TECHNICAL SERVICE BULLETIN

Glass Roof - Wind Noise From Upper Windshield Area Above 45 MPH (72 Km/H) - Built On Or Before 15-Feb-2021

21-2369

Ford 2021 Mustang Mach-E

Figure 1

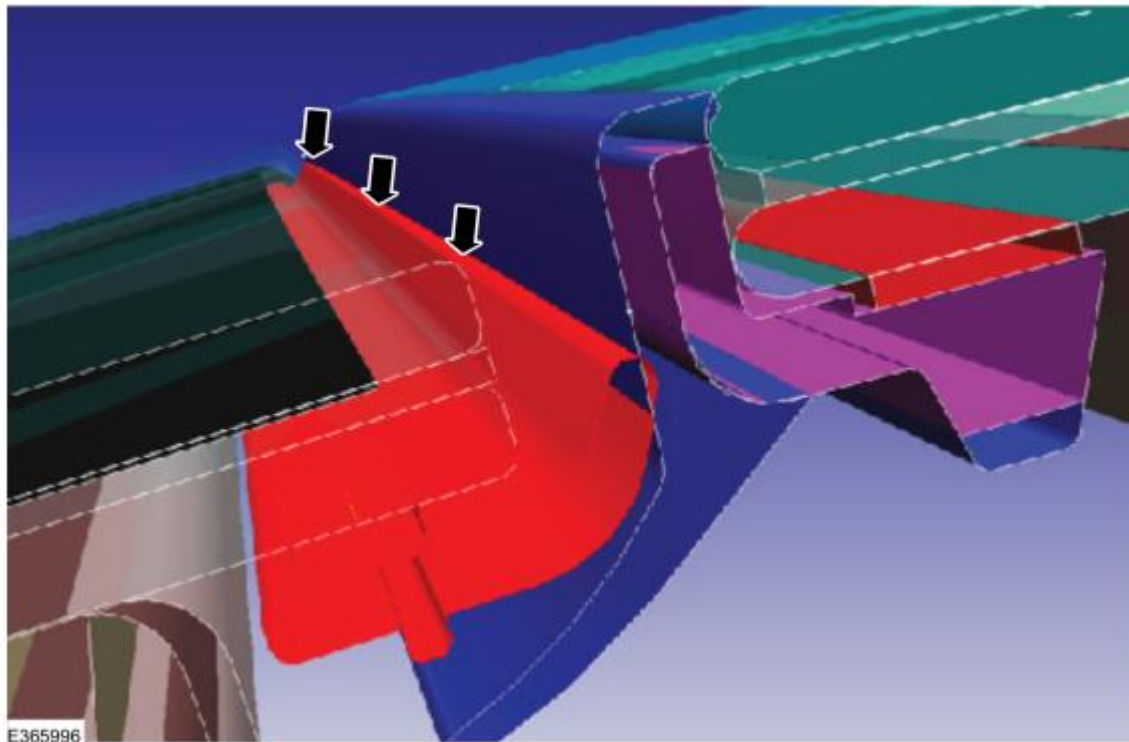
2. Using isopropyl alcohol and a clean cloth, clean and dry the channel between the roof glass and the windshield.

NOTE: The B side of the windshield must be clean to ensure proper adhesion. (Figure 1)

Figure 6

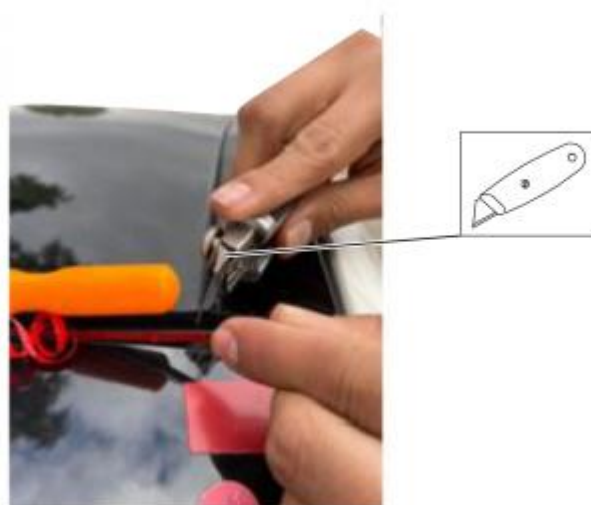
5. Using a knife/razor, cut the moulding at the other end of the roof glass. (Figures 6-7)
